**FINDINGS AND RECOMMENDATION
OFFICE OF PLANNING AND ZONING
ANNE ARUNDEL COUNTY, MARYLAND**

CASE NUMBER: 2024-0210-V

REQUEST

The applicants are requesting a variance to allow dwelling additions (decks) and associated facilities (steps, retaining walls, pathway, driveway) with less setbacks than required and with disturbance to slopes of 15% or greater on property located at 1695 Dunstable Green in Annapolis.

Administrative Site Plan

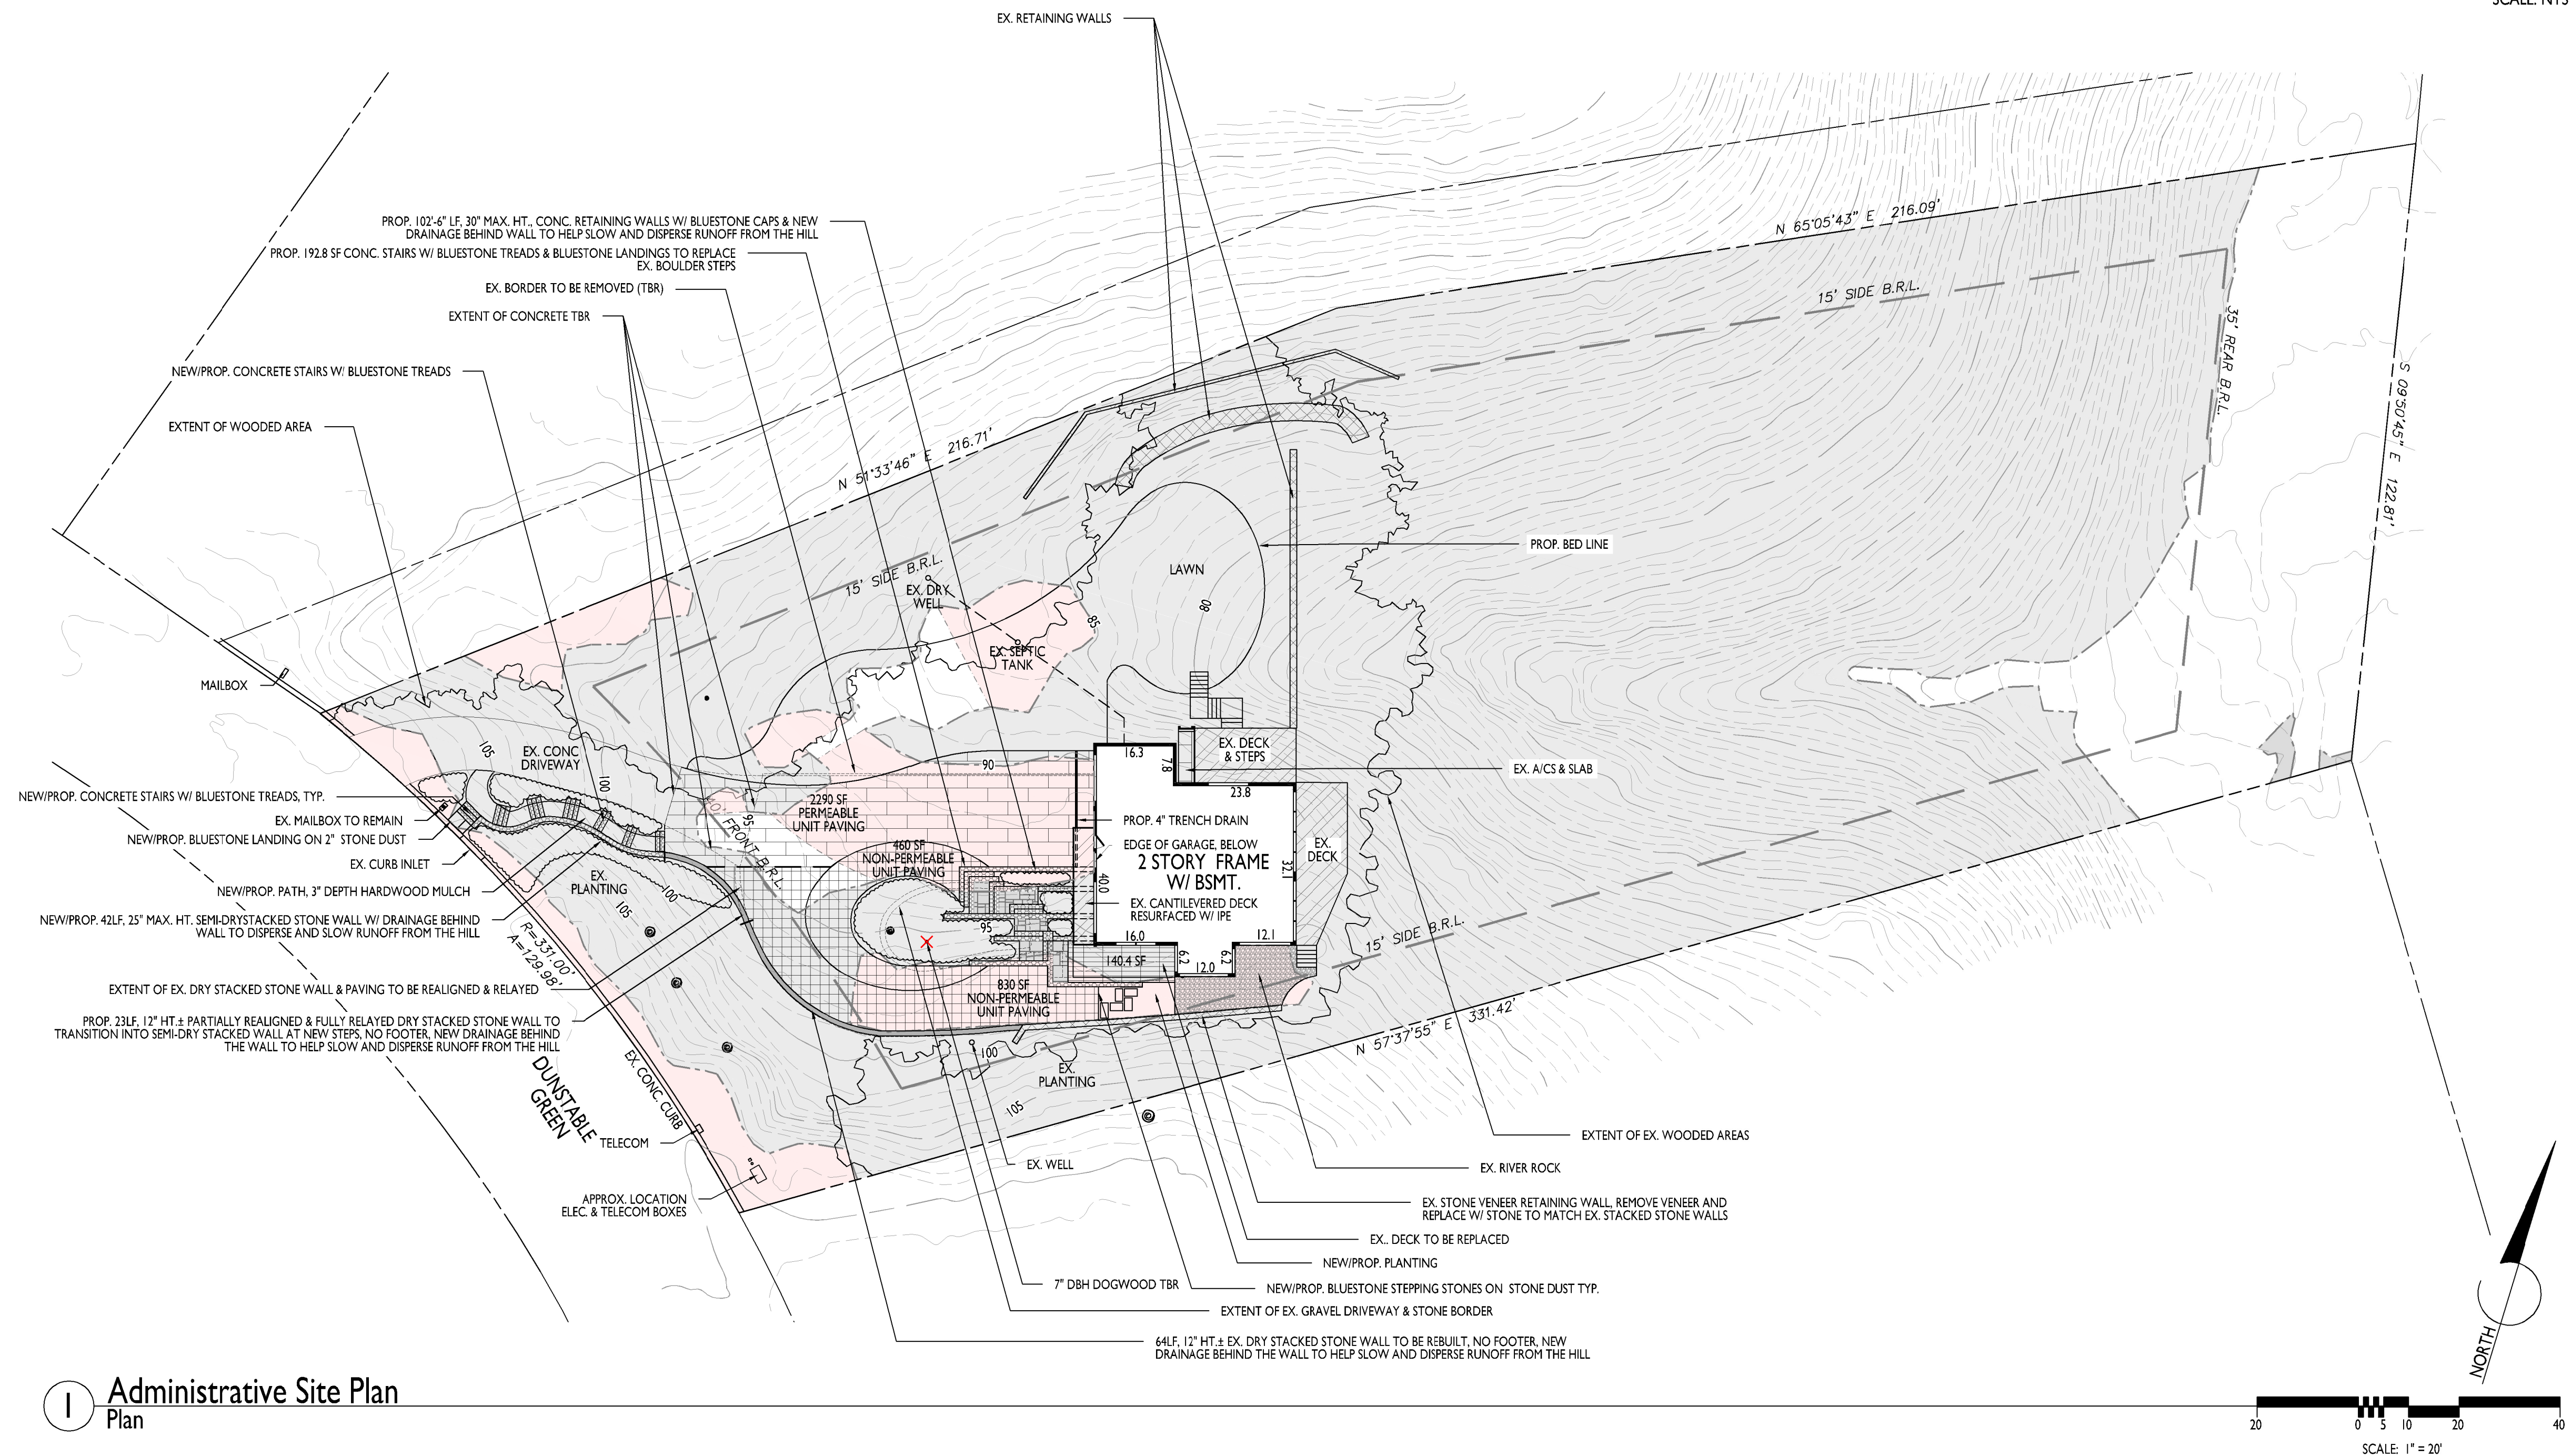
- The proposed reconfiguration will disturb slopes of 15% or greater, necessitating a variance. The final amount of permanent and temporary steep slope disturbance will be determined during permit review.¹

The **Critical Area Commission** noted that appropriate mitigation is required.

The **Health Department** has determined that the proposed request adversely affects the on-site sewage disposal and well water supply systems, and recommends denial.²

In this particular case, the property is encumbered by steep slopes, and the existing deck and steps are uneven and/or unsafe. The applicants' proposed reconfiguration is located generally within the existing footprint, and the new walkway and steps follow the slope.

The Health Department has reviewed the on-site sewage disposal and well water supply system for the above referenced property. The Health Department has determined that the proposed request adversely affects the on-site sewage disposal and well water supply systems. The Health Department recommends denial of the above referenced request. The proposed retaining walls and permeable pavers don't meet the required setbacks of 20' (variance with the Department of Health) and 100' respectfully..

Based upon the standards set forth in § 18-16-305 of the County Code under which a variance may be granted, this Office recommends *approval* of the Critical Area variance to § 17-8-201 to disturb steep slopes.

If granted, the final amount of disturbance will be determined during permit review.
